Rezoning Transportation Analysis

Petition Number: 2021-168

General Location Identifier: 07108107

Date	Description
11-19-2021	First Review (KP)

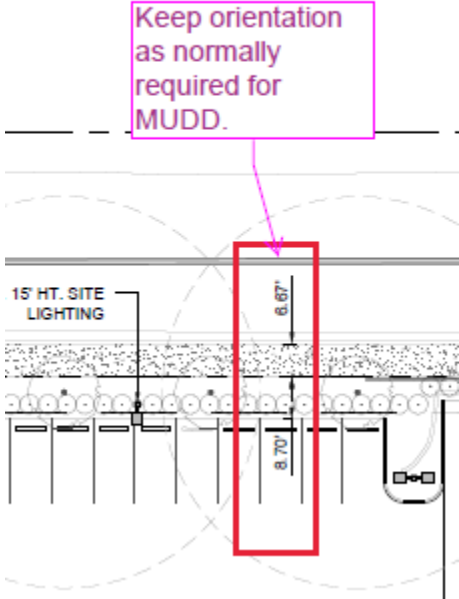
3. **Right-of-way:**

- a. **Berryhill Road:** Revise the site plan and conditional notes to commit to dedicated 36-feet of right-of-way from the existing road centerline, in accordance with CLDSM U-07 (Local Collector Street).
- b. **State Street:** Revise the site plan and conditional notes to commit to dedicated 36-feet of right-of-way from the existing road centerline, in accordance with CLDSM U-07 (Local Collector Street).

The site plan shall label and dimension the dedicated right-of-way from the existing centerline of each road.

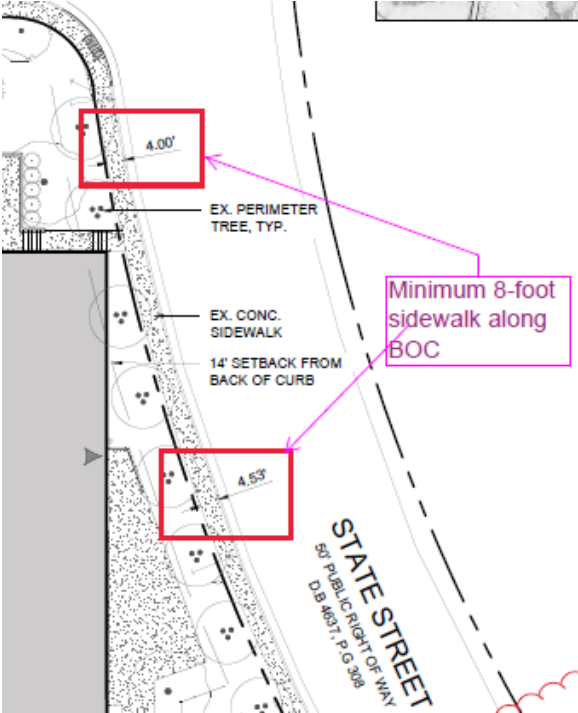
4. Revise site plan and conditional note(s) to commit to construct an 8-foot planting strip, and 6-foot sidewalk along the site's frontage of Berryhill Road and State Street. The planting strip and sidewalk shall be oriented where the planting strip is located in between the sidewalk and back-of-curb. The site plan shall label and dimension both items from the back of curb and gutter.

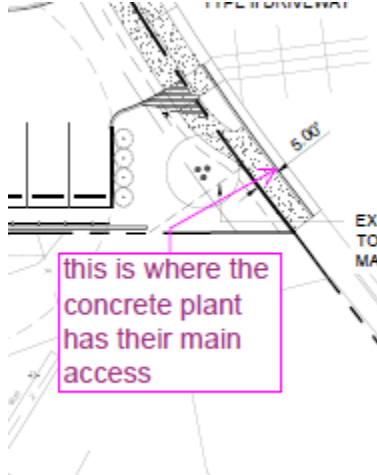
- 5. Revise site plan and conditional note(s) to commit to construct a minimum 8-foot sidewalk along the site's frontage of State Street and Berryhill Road where the sidewalk is located at the back-of-curb. Additionally, the sidewalk width will be maximized where the existing building(s) or other site constraints inhibit an 8-foot sidewalk. These location(s) and sidewalk width(s) will be subject to approval by CDOT during permitting. Lastly, remove conditional note 2.b.

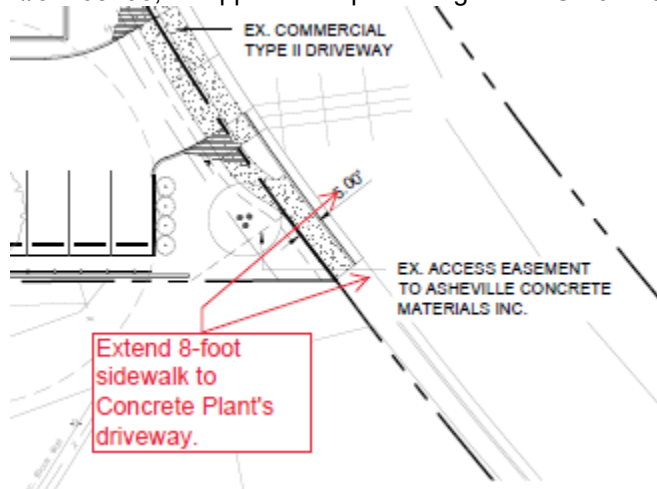
6. Revise the site plan and conditional notes by showing the driveway location associated with Asheville Concrete Materials, PID#07108106, as approved in permitting set LDC-2021-00081. This driveway shall not be affected by any improvements associated with this site.

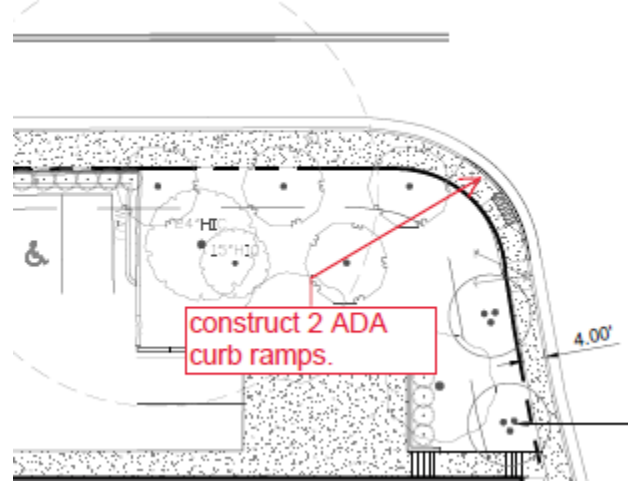
7. Revise the site plan and conditional notes by committing to connect the 8-foot sidewalk, located at the back-of-curb along the site's frontage of State Street, into the driveway associated with Asheville Concrete Materials, PID#07108106, as approved in permitting set LDC-2021-00081.
